Subject: Preservice Inspection Program (PSI) (SER Outstanding
Issue No. 4): Revised Relief Requests

Enclosed, herewith, please find revised Seabrook Station Unit 1 PSI
Relief Requests for examinations determined to be impractical pursuant to
10CFR50.55(a)(g)5(iii). These revisions are in accordance with our dis-
cussions with the Staff on June 11, 1986 regarding the relief requests
submitted by Reference (b). The revised relief requests included herewith
are listed below by number and subject.

Seabrook Nuclear Power Station Unit No. 1

Figure 1

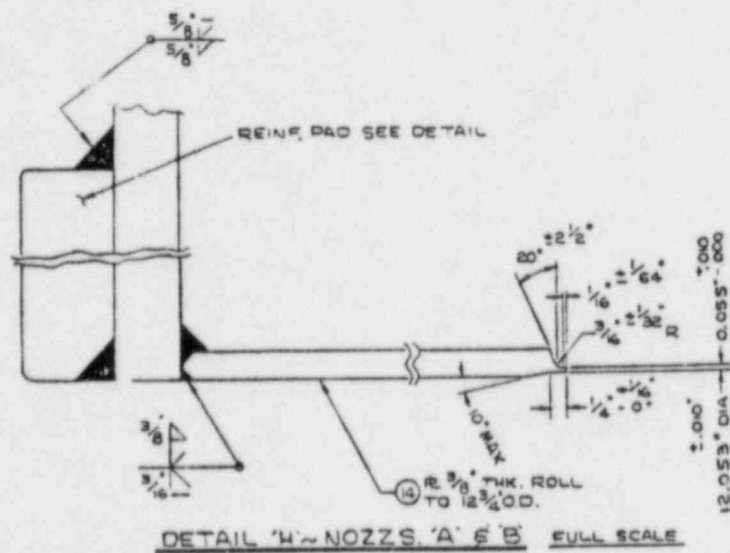
Pursuant to 10CFR50.55(a)(g)5(iii), relief is requested from performing the preservice ultrasonic examination of the nozzle to vessel welds on the tube side waterbox of the RHR Heat exchangers.

* Table IWC-2500-1, Category C-B, requires a volumetric examination of nozzle welds in vessels whose thickness exceeds 1/2" nominal. In the case of the Seabrook RHR Heat Exchangers, the weld geometry for the inlet and outlet nozzles do not have a configuration (Figure 1) which can be examined with ultrasonic techniques. The Pre-Service volumetric requirements will be fulfilled by the construction radiography.

Ultrasonic examination techniques will be developed, such that maximum coverage will be achieved at the first refueling outage.

1. Since the weld thickness is \leq 1/2" nominal, PSI examinations were performed in accordance with the requirements of Code Item Number C2.10 and Examination Requirements Figure IWC-2520-3 for nozzles in vessels 1/2" or less in nominal thickness.
2. The subject welds received both volumetric examination by radiography and surface examination during fabrication in accordance with the requirements of ASME Section III which provides adequate assurance of the structural integrity of the welds.

3. A preservice hydrostatic test was successfully conducted on the Class 2 portion of the heat exchanger, which includes the nozzle-to-shell welds, in accordance with ASME Section III.
4. Regular system pressure tests will be performed inservice in accordance with the requirements of Table IWC-2500-1, Category C-B.
- * 5. At the first refueling outage, the welds will be ultrasonically examined from the nozzle side using techniques developed on the Unit 2 heat exchangers.
